MEMORANDUM

Date: 31 July 2017

Revised Biobasin Locations for Stage 1 (West) Flagstone DEV2012/402

Figure 2 – Revised Catchment Plan and Basin Layout for Flagstone Stage 1 West (Based on RPS Layout July 2017)

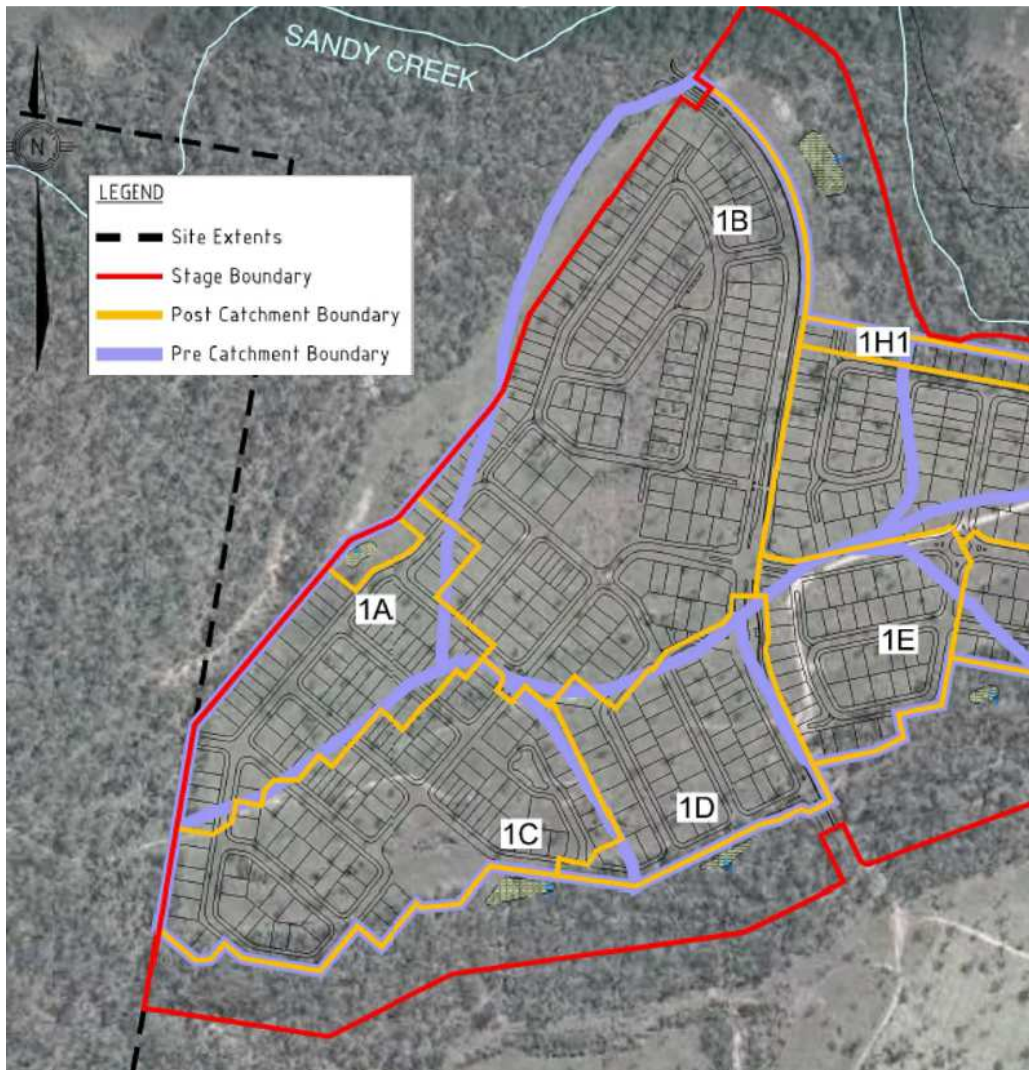
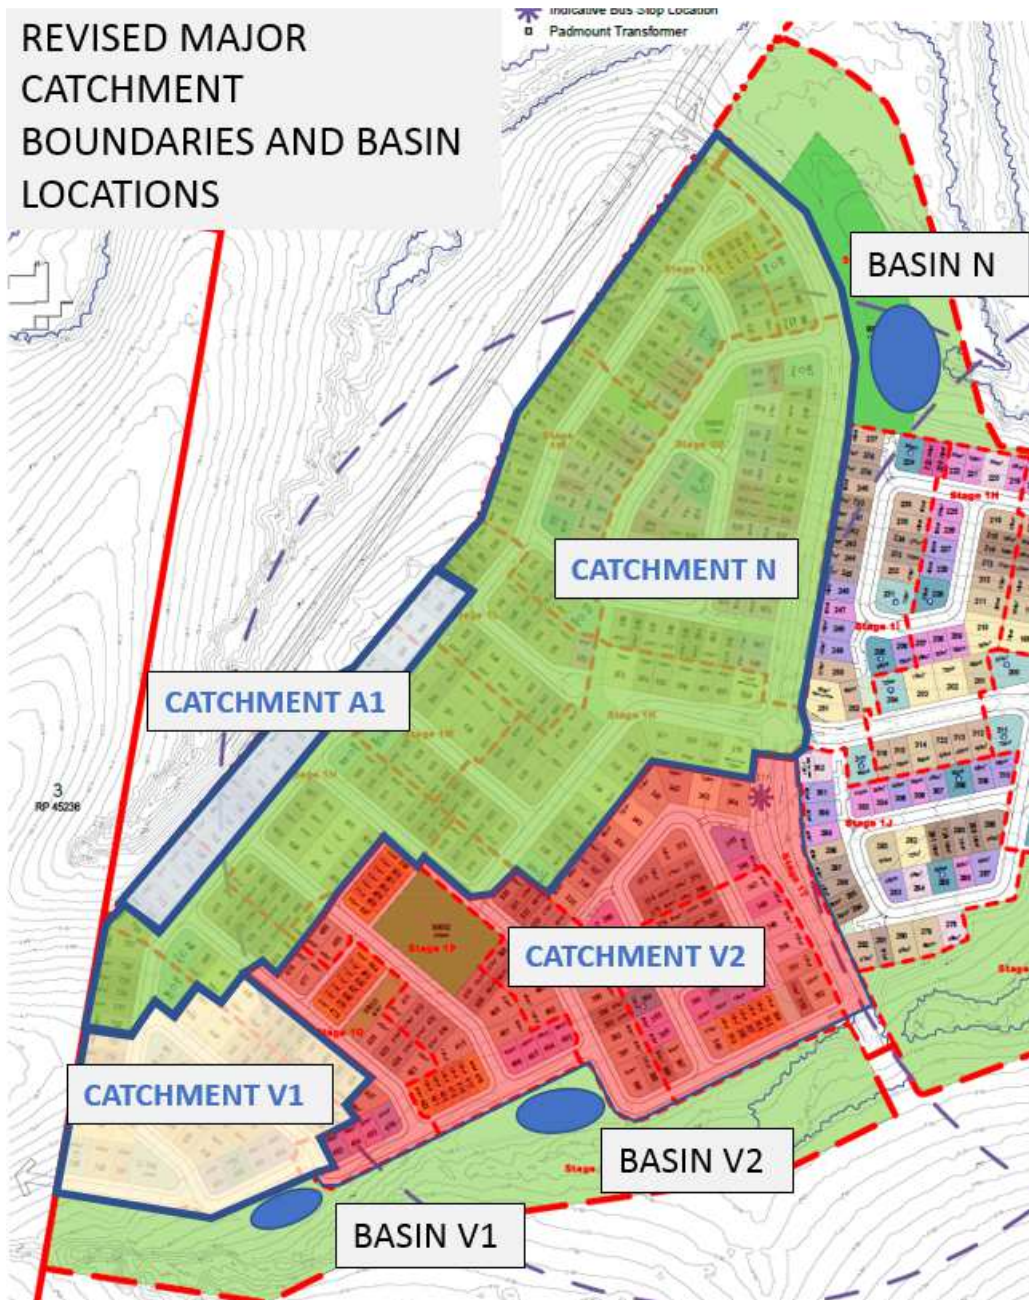
2. Whilst the overall design basis, design assumptions and parameters have not changed, due to the proposed revised layout of Stage 1 West [formerly known as Stage 1K – Stage 1Y], the bio-retention basins have been relocated to suit the new layout and adjustments to revised catchment boundaries.

7. Figure 1 detailed the original catchment plan and the original bio-retention basins.

8. Figure 2 details the revised catchment plan and bio-retention basins locations

10. Detention storage sizing was performed using XP-RAFTS utilising the same catchment parameters as per previous approved documents. The exception to this is Catchment A1, which contains land that sloped to the north-west. Whilst the low flow and roofwater captured in Catchment A1, for the purposes of water quality, is routed to Basin N; the excess runoff generated above Q10 events is discharged to the north-west boundary of Stage 1 (West). This excess peak runoff during a Q100 event is relatively distributed, is less than the overall Q100 pre-developed peak discharge, and is deemed to be acceptable.

11. The calculated 1 year ARI detention storage requirements for the revised basins are as follows:

Basin	Detention Base Area (m2)
N	3200
V1	506
V2	1322
Total	5028
